**SAFETY
RECALL**

Sr06-10

DATE : OCTOBER 2006	SECTION : 12
SUBJECT : BENDIX® SR-7™ SPRING BRAKE MODULATING VALVE

FIGURE1: SR-7 VALVE

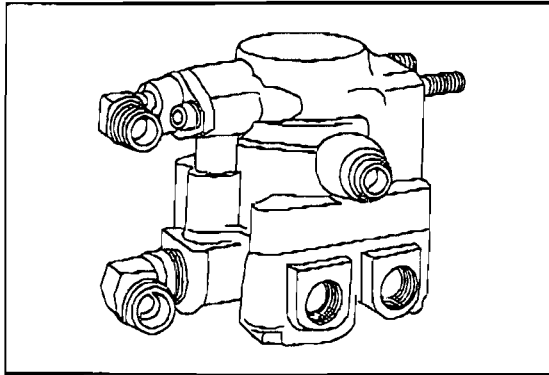
Bendix has determined that a check valve inside the Bendix® SR-7™ spring brake modulating valve may not properly seat, causing internal valve leakage. The leakage can result in delayed application of the spring brakes to park the vehicle upon pulling of the dash valve button. The delay, which could last up to three minutes, may be accompanied by secondary air leakage, such that the secondary reservoir is depleted. During this time, there is a risk that the vehicle can roll away. This issue does not affect the operation of the vehicles service brakes, however it could affect the emergency stopping distance in the event of a primary air system failure application of parking brakes.

Perform the steps indicated in **SR-7 Valve Recall Campaign Identification Guidelines (BW2585)** included with this Safety Recall to check if the SR-7™ spring brake modulating valve installed in your vehicle is subject to this recall campaign. **Only if the spring brake valve is identified as subject to this recall, perform procedure described in this bulletin to replace it with a new unit.**

3. Remove the L.H. side hinged rear fender or raise the vehicle to access the spring brake valve.
4. Identify all lines before disconnecting then disconnect the lines and hoses from the spring brake valve.
5. Remove the two mounting nuts that secure the valve to the frame rail then remove the valve.

1. Align the mounting studs with the mounting holes on the vehicle frame rail. Tighten the mounting nuts to 180-220 inch-lbs.
2. Install the valve (642015) onto the vehicle ensuring all ports are connected as marked during disassembly.

FIGURE 2: AIR-OPERATED BRAKING SYSTEM H3

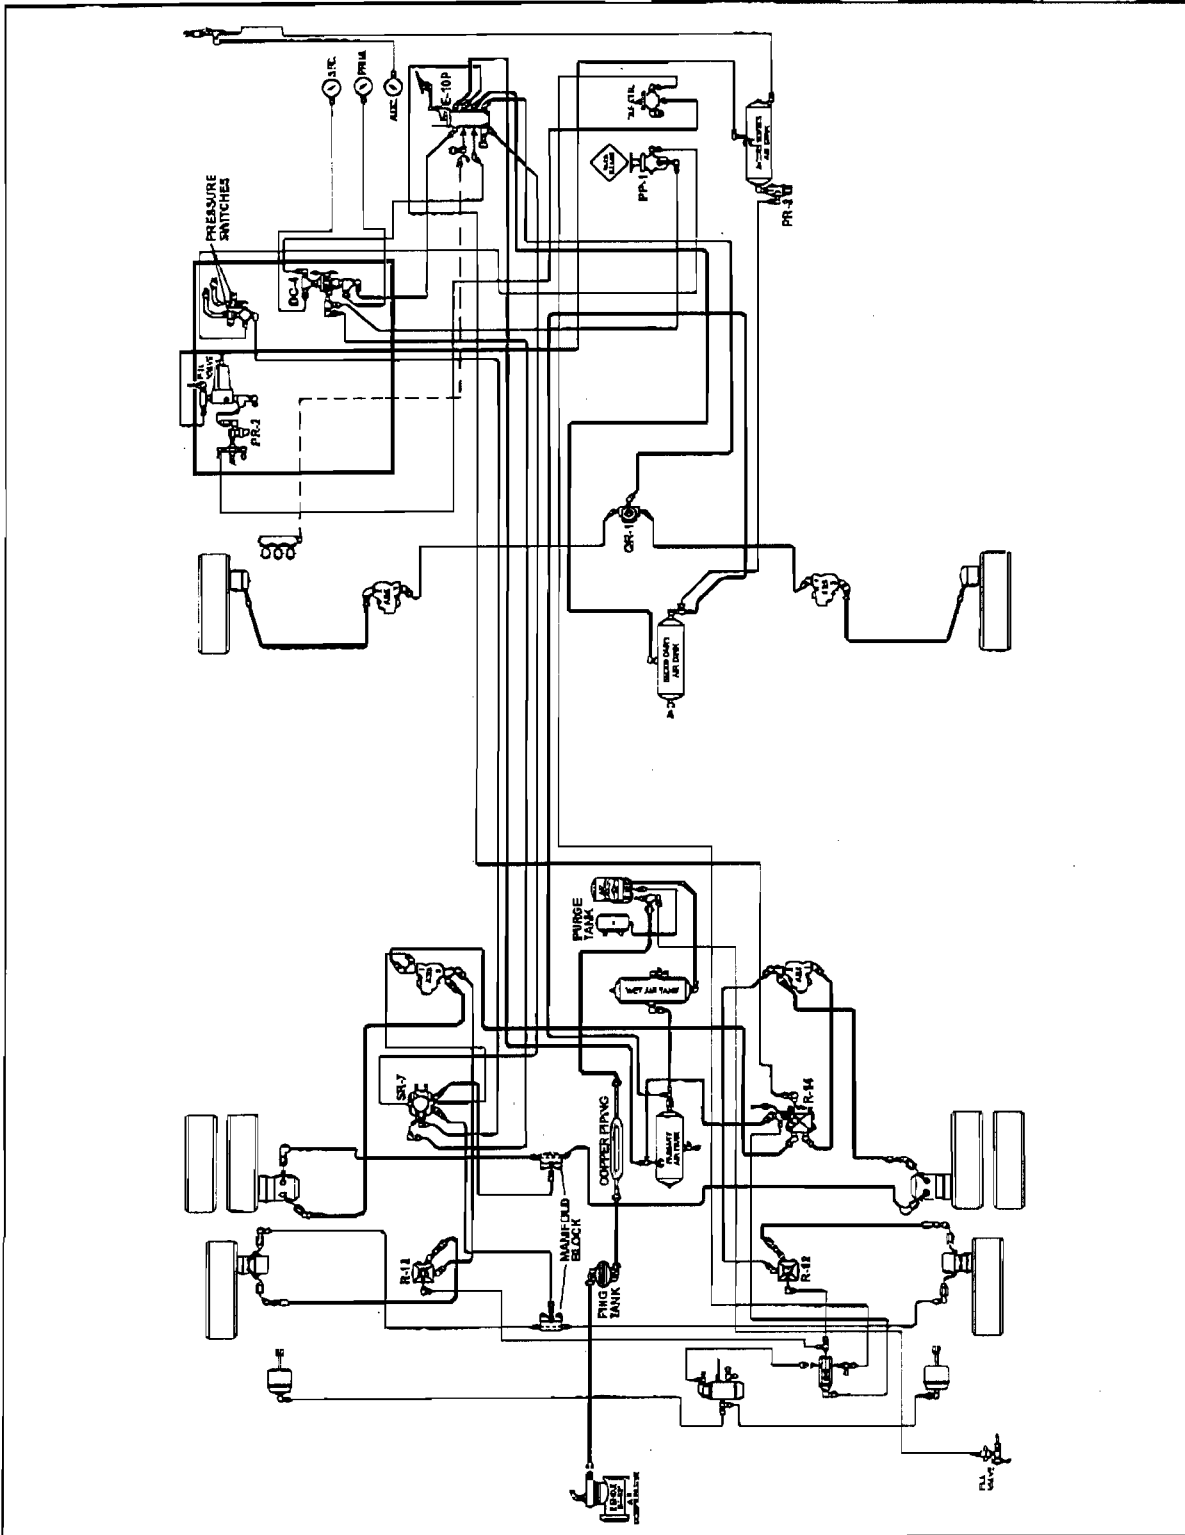
1. Drain all vehicle reservoirs.
2. The spring brake valve is located above the drive axle, behind the L.H. side hinged rear fender (Refer to figure 2 for H3 vehicles) or in the rear underframe (Refer to figures 3 & 4 for X3-45 coaches).

Step 1: Identify the casting as either Bendix 1 or Bendix 2.
(Located on the side of the valve as shown.)

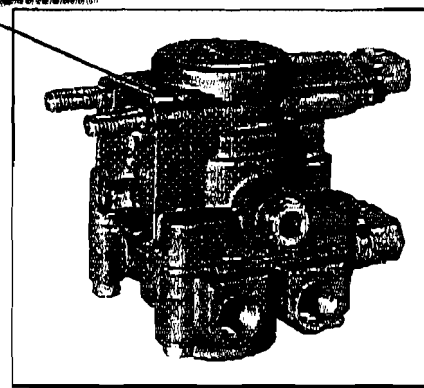
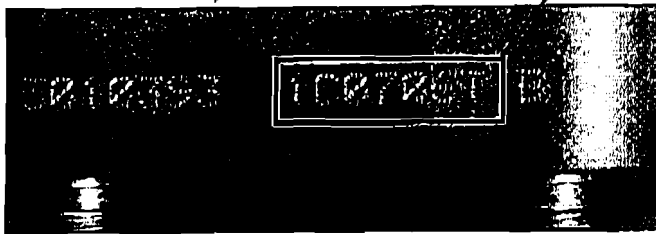
If the casting has "Bendix 1" on the side, it is potentially affected by the recall campaign and must be further identified.

If the casting has "Bendix 2" on the side, it is not affected by the recall campaign, and no further action is required.

Date Code Location

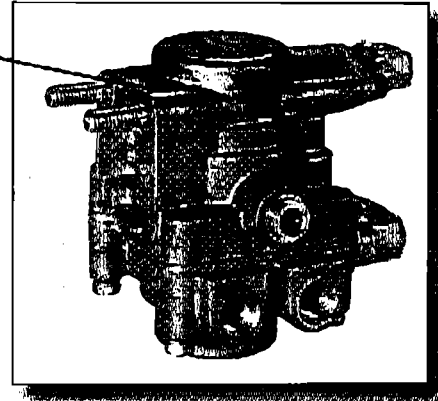
SR-7™ valves with the casting code "Bendix 1" manufactured between April 1, 2006 and May 24, 2006 are subject to the recall campaign and must be replaced.

The second character in the date code is an alpha character representing the month of manufacture (A through M skipping the letter I) corresponding to January through December (D = April and E = May). The next four characters are numbers representing the two digit day of the month followed by the two digit year. For example the date code 1C0706T, key characters C0706, indicates the valve was manufactured 3-07-06 or March 7, 2006.

SR-7™ valves with a casting code "Bendix 1" and the following date codes are subject to the recall campaign and must be replaced per the SR-7™ Recall Campaign Guidelines.

D0106 (April 1, 2006) through _E2406_ (May 24, 2006) inclusive.
